NP-11-0035  
August 4, 2011

Subject: Exelon Nuclear Texas Holdings, LLC  
Victoria County Station Early Site Permit Application  
Response to Request for Additional Information Letter No. 09  
NRC Docket No. 52-042

**Figure 1. Location of Cross Sections and Profiles**

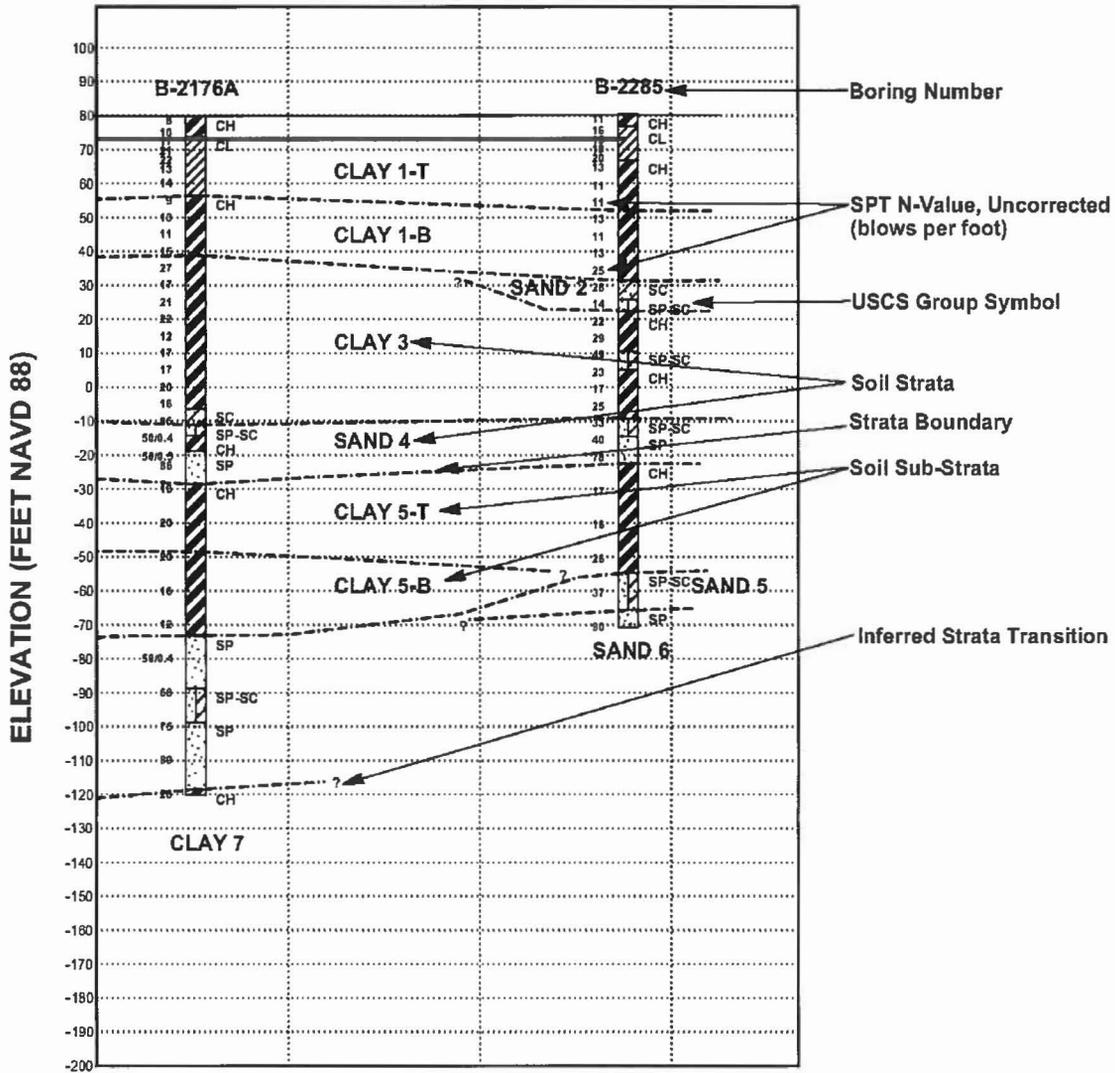
In SSAR Section 2.5 there are several cross-sections of shallow subsurface borehole data: Figures 2.5.1-34 and 35, and 2.5.4- 14, -15, and -16. For example, Fig. 2.5.4-14 shows a gentle step in topography and apparent offset of the Sand 1 / Clay 1-B contact between boreholes B-2302A and B-2308, which straddle the mapped trace of fault D.

- a. In support of 10 CFR 100.23(d)(2), and in order for the staff to evaluate the shallow subsurface units with respect to the presence (or lack thereof) of the fault, please develop cross-sections orthogonal to the trace of the fault and reevaluate the data to determine if there is an indication of a fault in the shallow subsurface.

Please add the following on all cross-section figures: stratigraphic or lithologic contacts (e.g. as shown in Figure 2.5.1-34); surface topography based on LiDAR; location of caliche layers; and location of fault(s). Also provide an explanation of the lithologic strip log.

The locations of the cross sections (X-X', Y-Y', W-W', and Z-Z') and profiles (E, F, and G) are shown in Figure 1. The explanation of the lithologies in the cross sections and profiles is shown as a legend in Figure 2. Cross sections X-X' and Y-Y' (Figures 3 and 4) were developed from the cross sections shown in SSAR Figures 2.5.1-34 and -35 while profiles E, F, and G (Figures 7, 8, and 9) were developed from the profiles shown in SSAR Figures 2.5.4-14, -15, and -16. Cross sections W-W' and Z-Z' (Figures 5 and 6) are new cross sections. With the exception of cross section X-X', all of the cross sections and profiles show the detailed stratigraphy beneath the site,

The LiDAR-derived topography data shown on the cross sections and profiles described above does not suggest that there is displacement or offset of the shallow soil strata underlying the site. That is, there appears to be no correlation between surface topography and irregular soil strata contacts. The gentle topographic slope between borings B-2302A and B-2303A shown in Profile E in Figure 7 appears to reflect the slope of the surface of the Beaumont Formation. The Sand 1/Clay 1-B contact is interpreted to be a distributary channel centered along boring B-2308 and flanked by overbank deposits and clay flats. This interpretation is preferred to a fault offset because the down-to-the-south sense of displacement is contradicted by the rise in the underlying Clay 1-B/Sand 2 contact. Cross sections W-W' and Z-Z' shown in Figures 5 and 6, respectively, also show gently dipping strata in the envelope of the potential zone of deformation, inferred to be distributary channel or overbank deposits, while the remaining cross sections and profiles generally show planar soil strata.

**Figure 1. Location of Fault E LiDAR Profiles.**

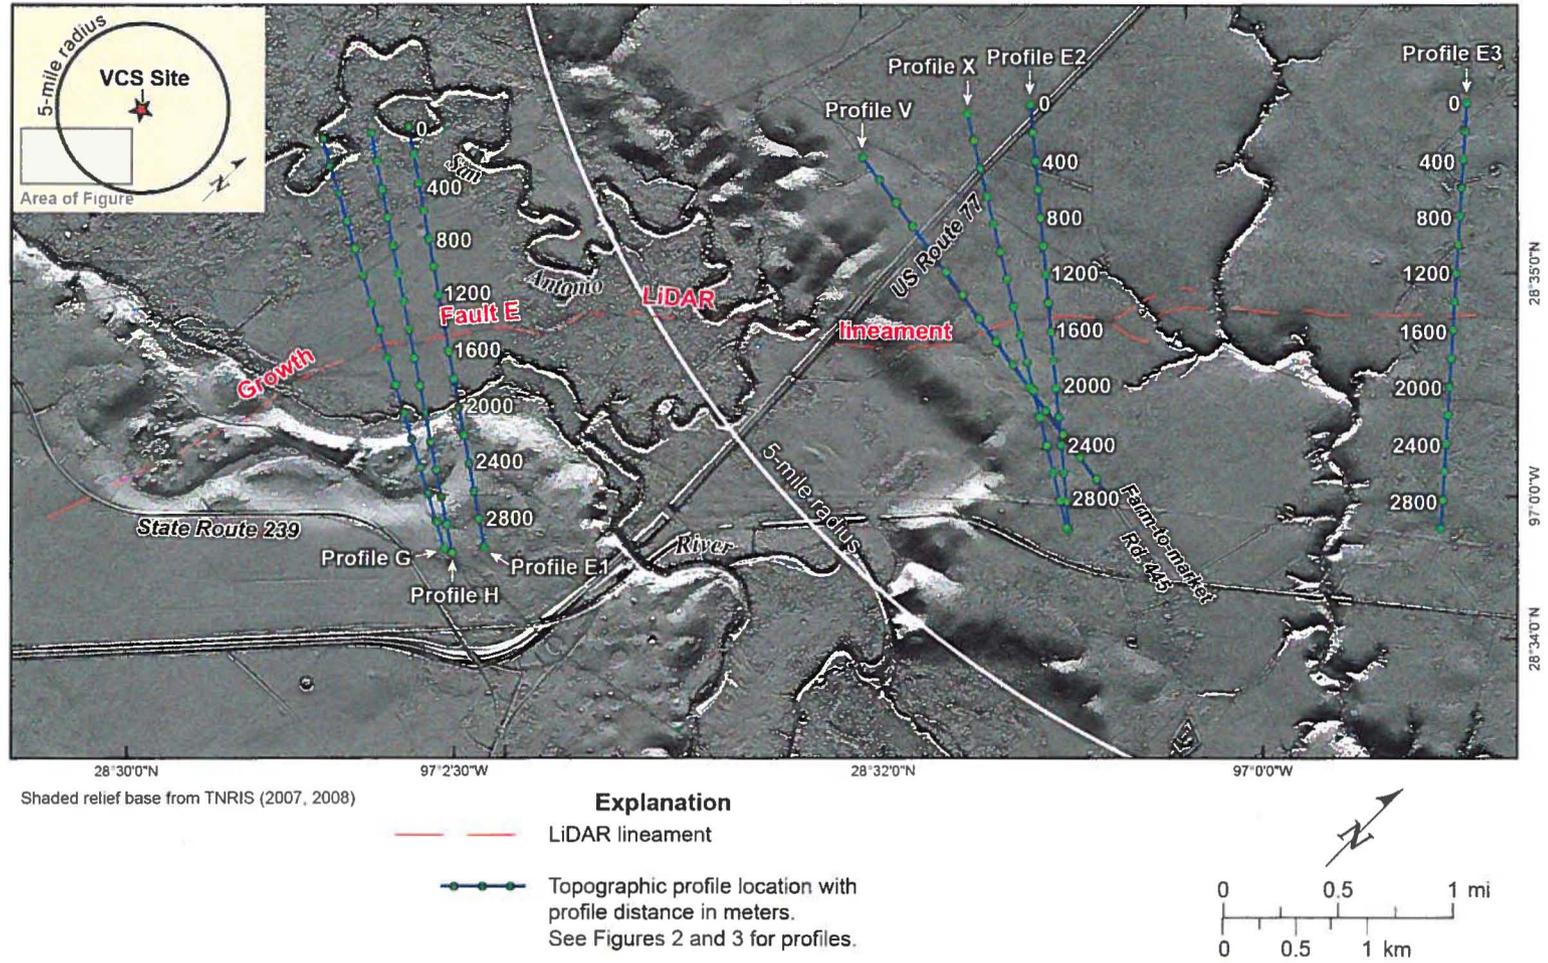
1. Present and compare topographic profiles of the fault E lineament in Beaumont, Holocene, and historic-aged deposits that document along-strike variations in fault topographic profile size and morphology. Discuss the implications of these comparisons for the age of initiation of fault E.
2. Discuss evidence for historical activity on faults D and E in light of recent public report that indicates growth fault E offsets pavement 8 inches on McFaddin Rd where the LiDAR lineament crosses this roadway.
3. Provide a re-evaluation of the rate of movement on fault D in light of these concerns and observations.
4. Compare these rates to published rates from other active growth faults in the region such as those in the Houston area.

Figures 1 through 3 illustrate seven topographic profiles across growth fault E that crosses historic fill along FM Road 445 (called McFaddin Road in the RAI above), Holocene deposits, and Pleistocene deposits. Figure 1 shows the map view of the LiDAR lineament associated growth fault E and location of each topographic profile (including stationing along each profile). Figure 2 illustrates three profiles (G, H, and E1) across the LiDAR lineament where it is mapped across the Holocene San Antonio River floodplain (~10,000 year old; see response to RAI 02.05.01-1 for further discussion). Figure 3 illustrates one profile (V) across the FM Road 445 in artificial fill deposits (<100 yrs old) and three profiles (X, E2, and E3) in the Beaumont Formation deposits ( $\geq 100,000$  years old) (See SSAR Subsections 2.5.1.2.3. and 2.5.1.2.4.2.3.3 for more details). Profiles E1, E2, and E3 are reproductions from Figure 2 in the response to RAI 02.05.01-11. Profile V was chosen because it is located in the middle of the FM Road 445. The other profiles shown in Figures 2 and 3 were chosen because they represented a subsample of topographic profiles where the LiDAR lineament associated with growth fault E is well-expressed topographically. For example, the LiDAR lineament crosses a small drainage between profiles E2 and E3 and splits into three different splays. Topographic profiles across this area do not show a well-resolved lineament, and therefore are not useful in a discussion of the age of initiation of growth fault E.
